**BRUNSWICK-TOPSHAM BRIDGE  
DESIGN ADVISORY COMMITTEE**

**PRELIMINARY  
REPORT  
on  
DESIGN  
RECOMMENDATIONS**

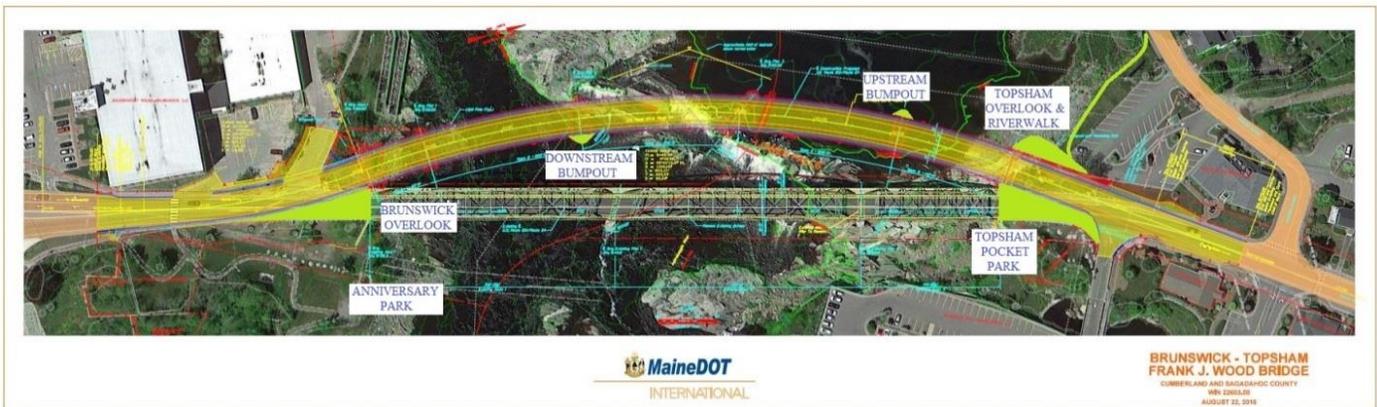
- There should be sidewalks on both sides of the bridge. Walkers should no longer need to cross Main/e Street at both ends of the bridge, which today can be dangerous, especially for people who are the elderly, disabled, or accompanied by small children.
- There should be safe and adequate bicycle lanes on both sides of the bridge.
- We recommend the width of the bridge should be allocated as follows (see image 1.1 Bridge Cross Section):
  - Two 11-foot motor vehicle lanes,
  - Two 5-foot shoulder/bikeways, and
  - Two 6'-4" sidewalks.

2.2 Rendering of wall/railing showing with lamp posts and arch-shaped insets

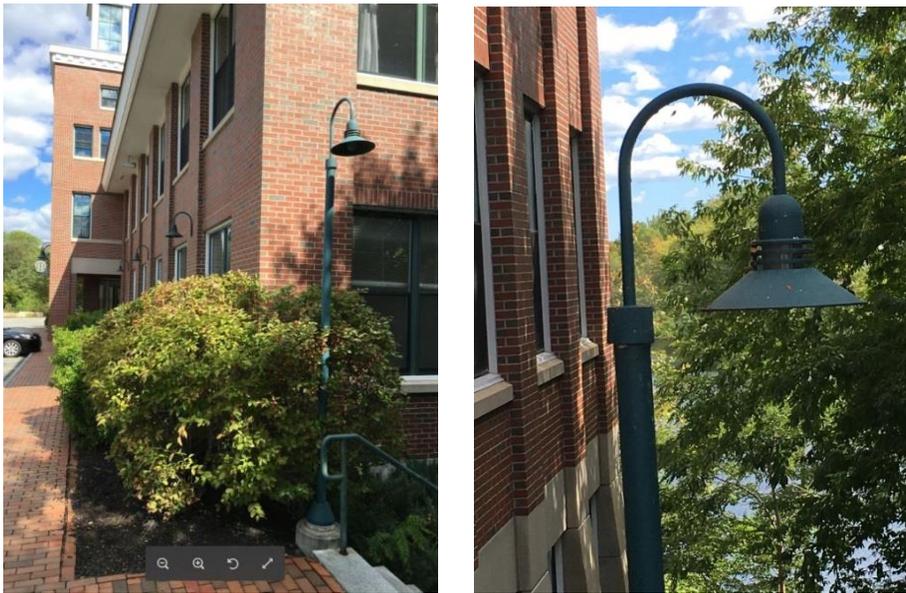
After much discussion and review of numerous rail types, the DAC drew inspiration from a bridge in a village in Vermont (see image 2.1 below) and suggests that the rail instead be a solid concrete lower portion with arch insets, a metal rail upper, concrete posts with pedestal lamp posts incorporated within them at the appropriate spacing. This

wall/railing will pass crash standards, will complement area architecture, screens headlights, makes the bridge feel more like a bridge for pedestrians, allows the curve theme to continue with arch insets like the piers, and is aesthetically more pleasing.

The DAC recommends the bridge lamp posts shown in image 2.2, above. They reflect the area examples, are simple, promote the curve theme, and their black color will match lamps in both Brunswick and Topsham. These posts should be outfitted with flagpole hardware to allow the display of flags or banners.

3.1 Approximate location of pedestrian amenities on or near the new bridge

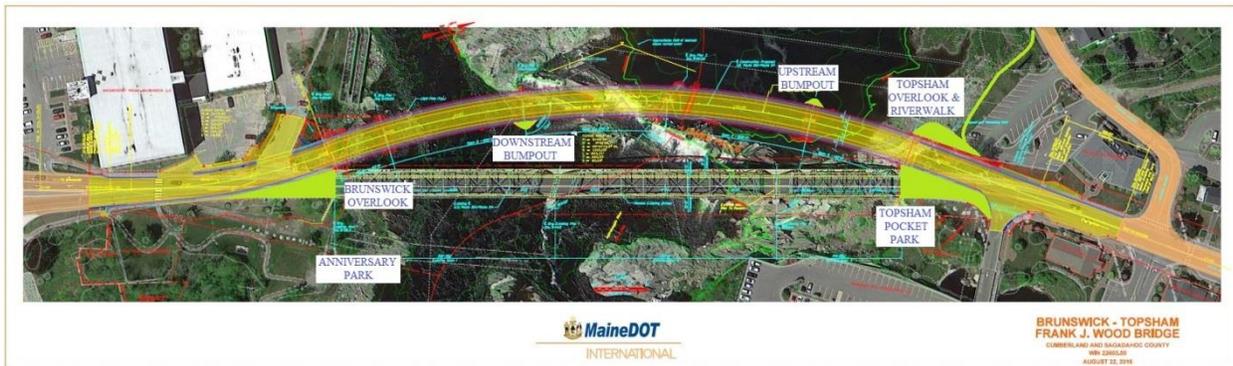
Although the precise number and location of the bumpouts deserves further consideration, at this time the DAC suggests that given the other pedestrian amenities noted below, the bridge should have two bumpouts.

For structural support reasons, MaineDOT wants the bumpouts to be located over piers. The DAC suggests that the upstream or westerly bumpout be located over a pier nearer to the Topsham side to allow the view of high spring water, area architecture, and longer upstream views. For similar reasons, the DAC recommends that the downstream or easterly bumpout be located over year round water closer to the Brunswick side, which will again highlight the rediscovered beautiful downstream views. This downstream bumpout would also provide an improved venue for the wreath ceremony that takes place every Memorial Day. See image 3.1 for bumpout locations.

4.1 Basic Pier Types

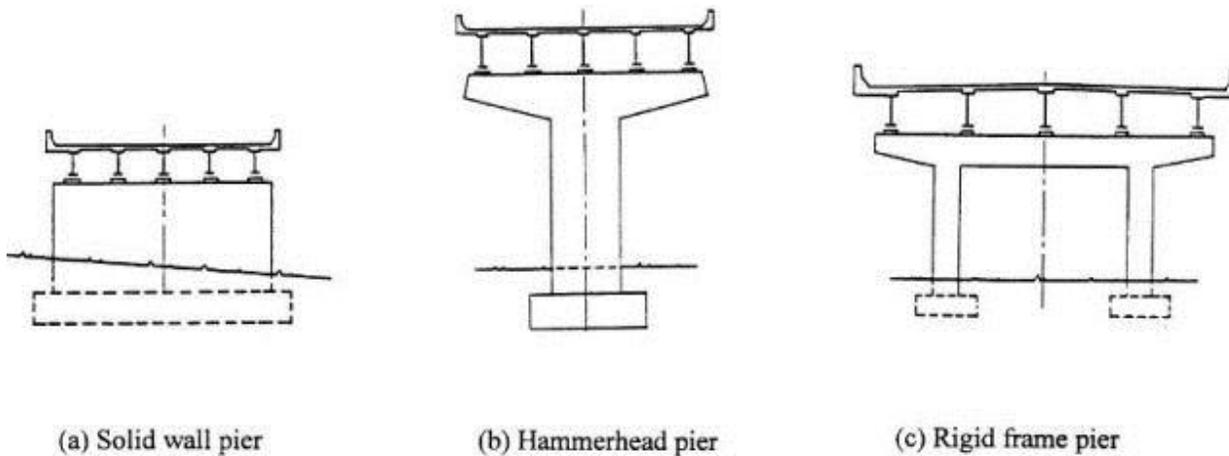
The DAC reviewed many options. Initially, many DAC members were attracted to the reduced mass and more light provided by a hammerhead pier type. But many thought such a pier seemed too modern, too much like other “cookie-cutter” bridges, and not fitting to the site.

1. The piers should be a tapered concrete trapezoidal shape with an ashlar finish.
2. The footings for the piers should be as low profile and unobtrusive as possible, perhaps with rounded or angled top edges to reduce mass and minimize the opportunities for graffiti.
3. The abutments should also have an ashlar finish.
